Title - Sujet New 50 Man Living Units - Ferndale	
Solicitation No. - N° de l'invitation EZ899-131401/A	Amendment No. - N° modif. 004
Client Reference No. - N° de référence du client	Date 2012-11-02
GETS Reference No. - N° de référence de SEAG PW-\$PWY-005-6794	
File No. - N° de dossier PWY-2-35164 (005)	CCC No./N° CCC - FMS No./N° VME
Solicitation Closes - L'invitation prend fin at - à 02:00 PM on - le 2012-11-09	Time Zone Fuseau horaire Pacific Daylight Saving Time PDT
F.O.B. - F.A.B. Plant-Usine: <input type="checkbox"/> Destination: <input checked="" type="checkbox"/> Other-Autre: <input type="checkbox"/>	
Address Enquiries to: - Adresser toutes questions à: Pillay, Sal (PWY)	Buyer Id - Id de l'acheteur pwy005
Telephone No. - N° de téléphone (604) 775-9386 ()	FAX No. - N° de FAX (604) 775-6633
Destination - of Goods, Services, and Construction: Destination - des biens, services et construction: CSC - Ferndale Institution - Mission, BC

Refer to the attached Addendum No. 3 issued 2nd November 2012.

The following changes in the tender documents are effective immediately. This addendum will form part of the contract documents.

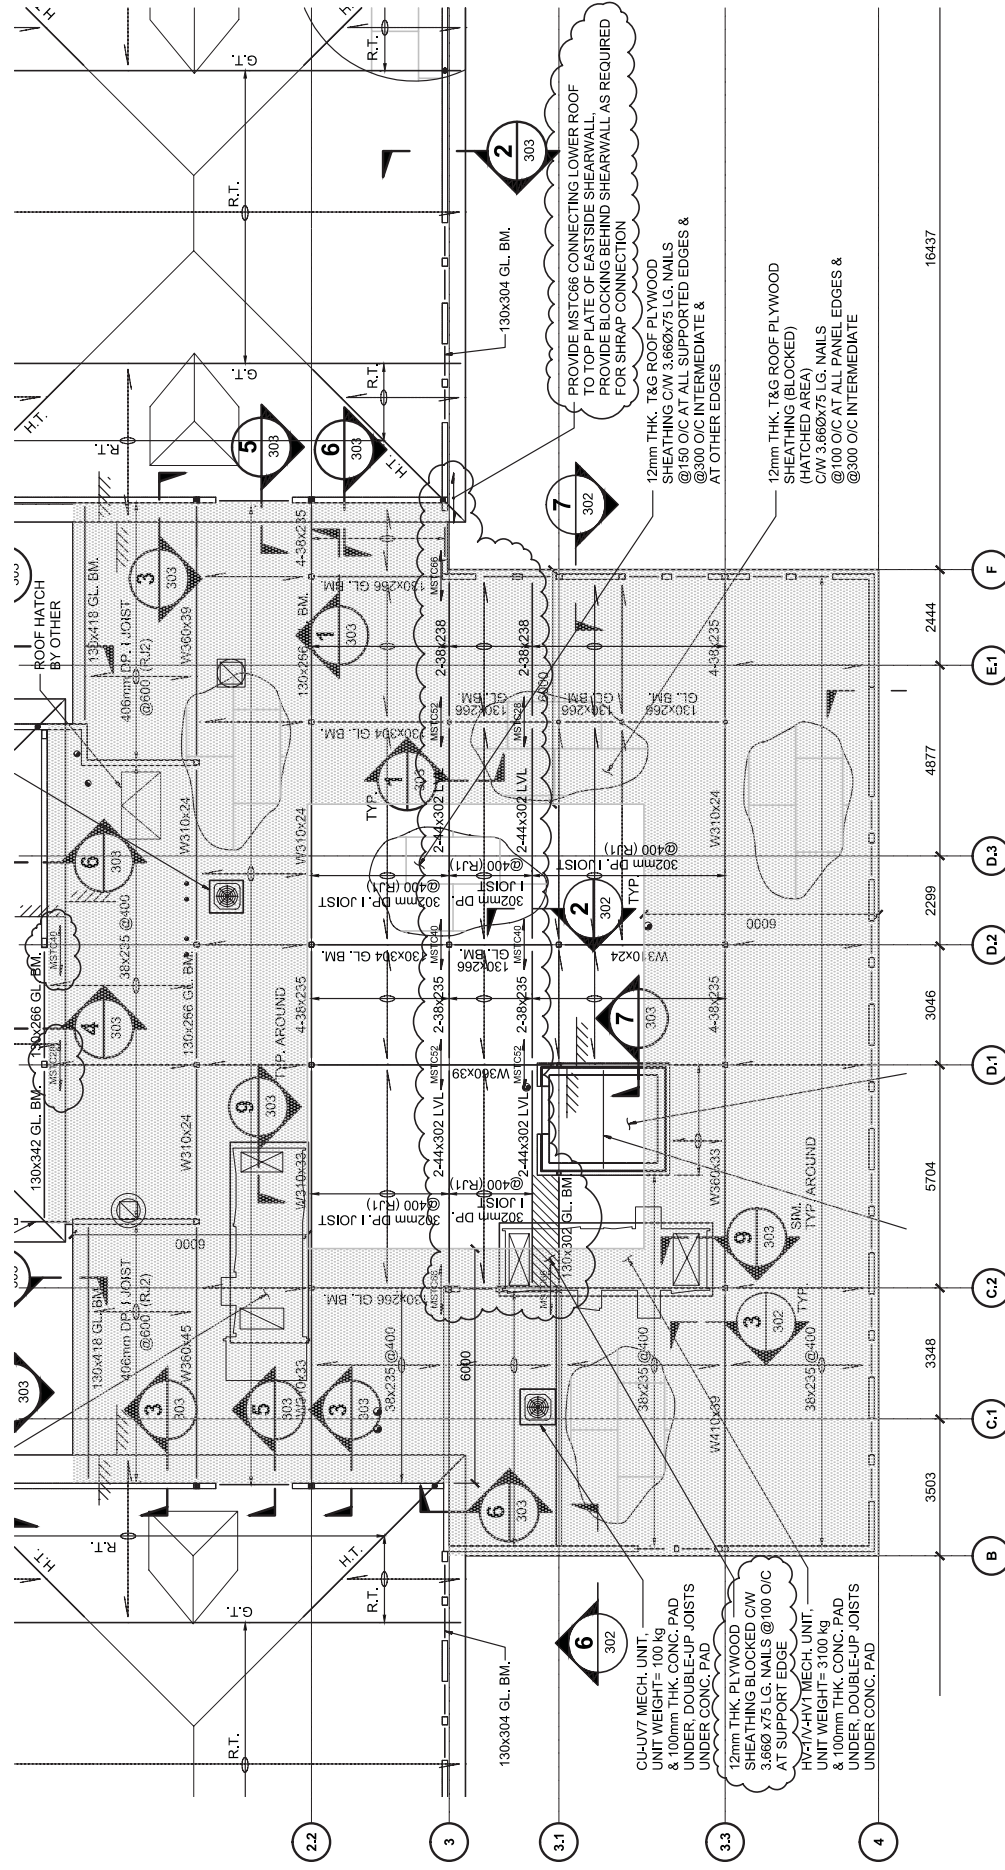
| .1 | S-AD-S03 | Second Floor Framing Plan Revised |
| .2 | S-AD-S04 | Second Floor Framing Plan Revised |

SHEARWALL SCHEDULE REVISED
(XREF. DWG. SF-401)

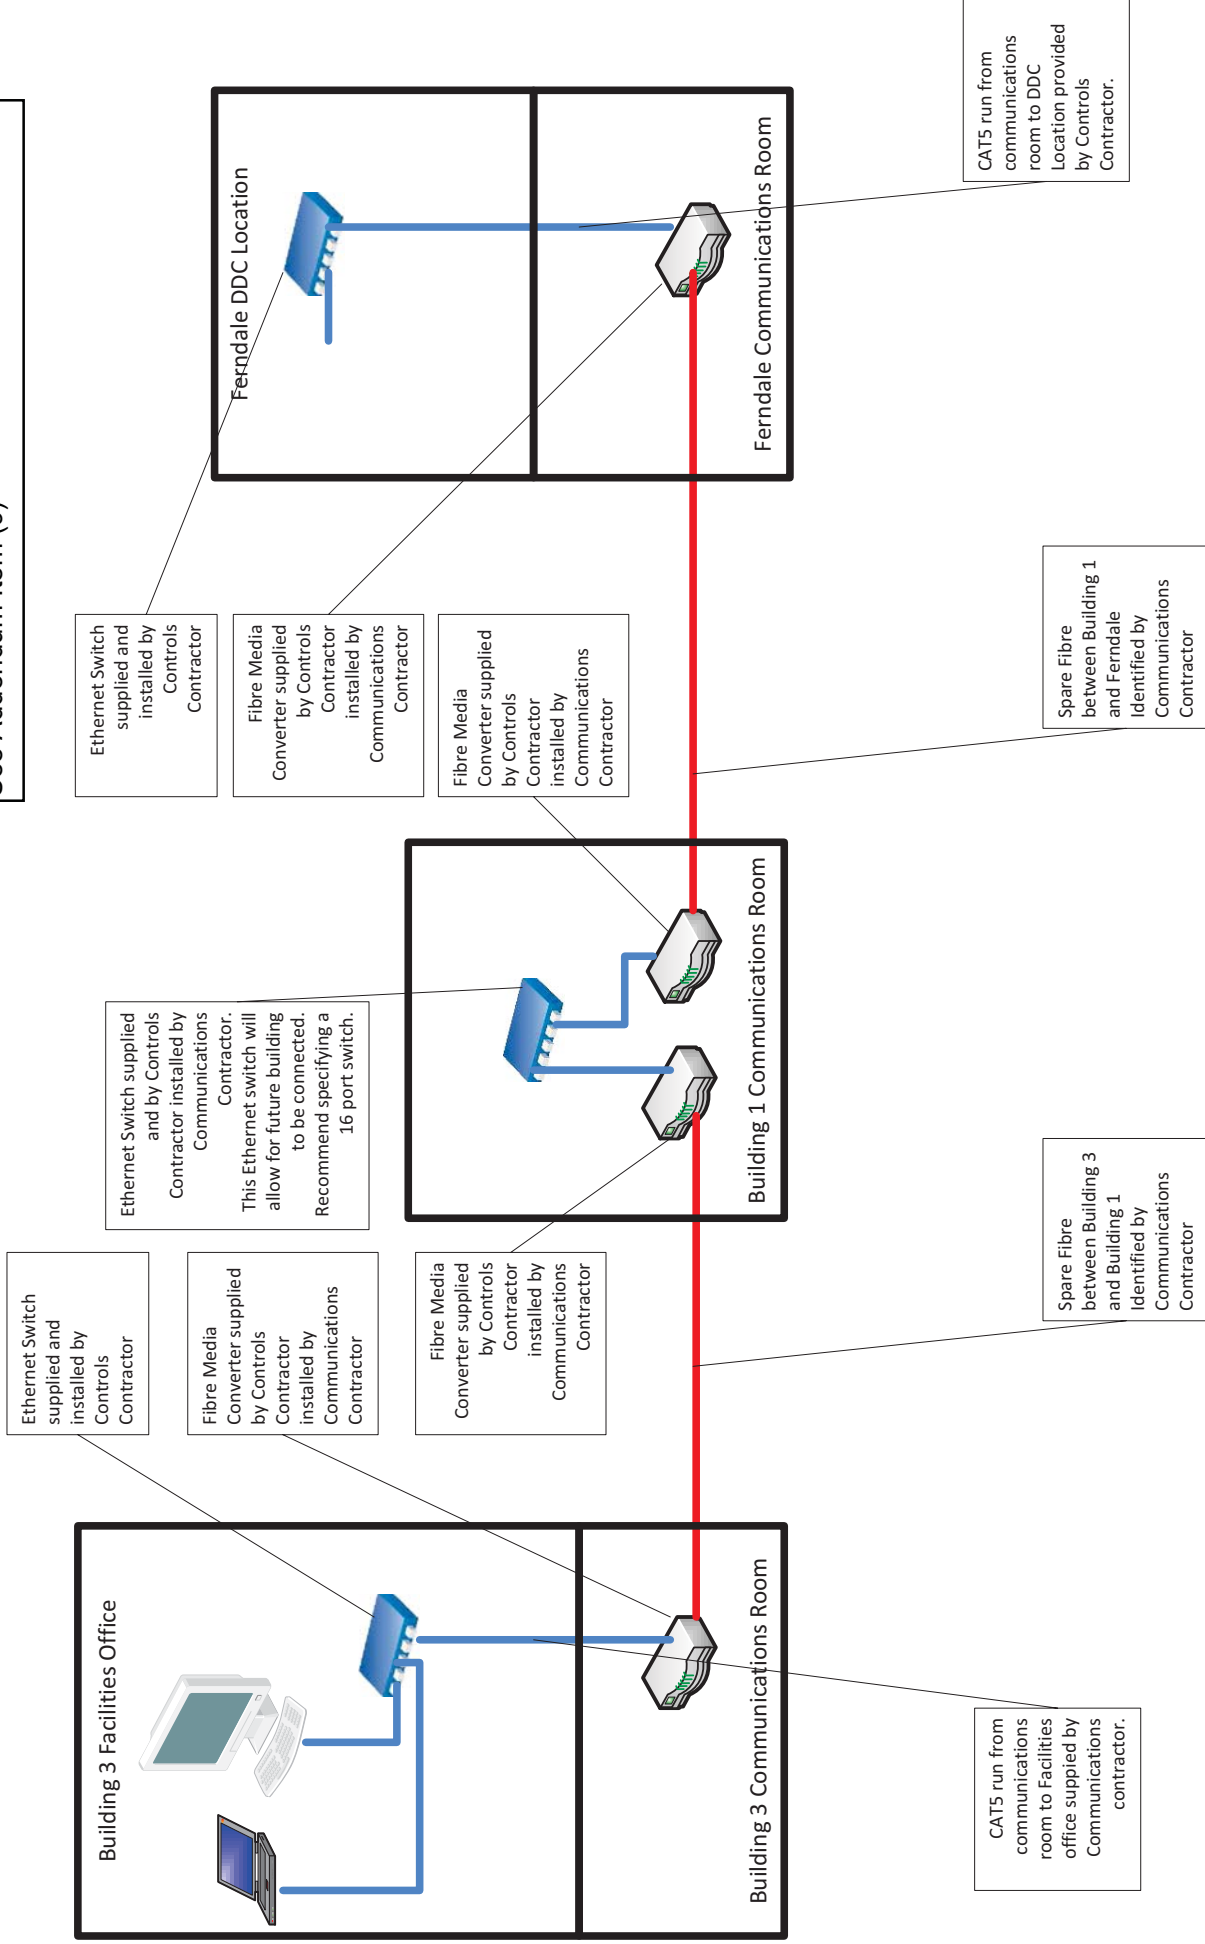
(39) **Revise:** Shear Wall Schedule for wall types SW3/SW5, SW7 & SW8 as per attached addendum sketch AD-S05.

Proj. No. R04494.001	Scale: N.T.S.	Date: 12Oct31	Designed: K.B.	Drawing No.: ESK-E004-01
-------------------------	------------------	------------------	-------------------	-----------------------------

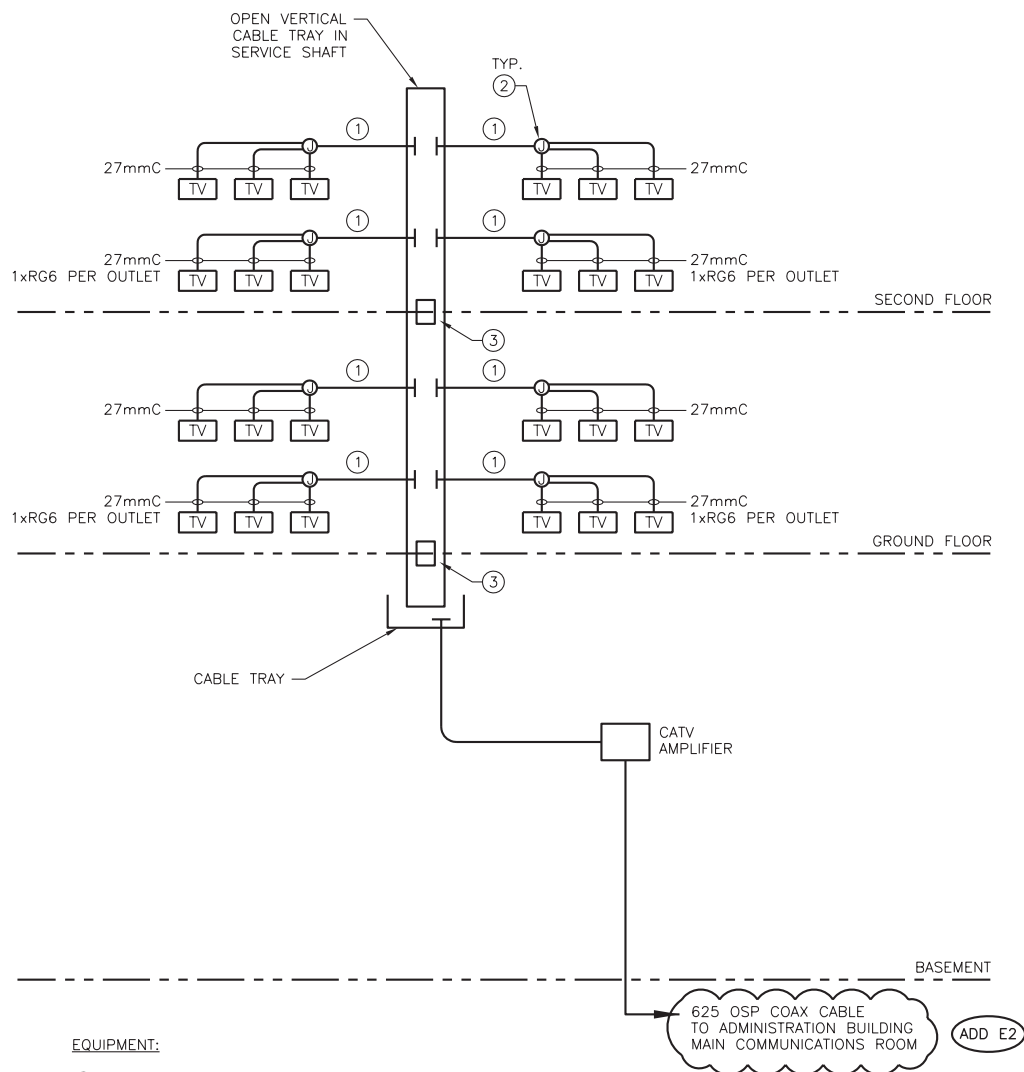
- (46) **Replace:** Detail B with detail shown in ESK-E004-01.
- (47) **Replace:** Detail C with detail shown in ESK-E004-02.
- (48) **Replace:** Detail D with detail shown in ESK-E004-03.
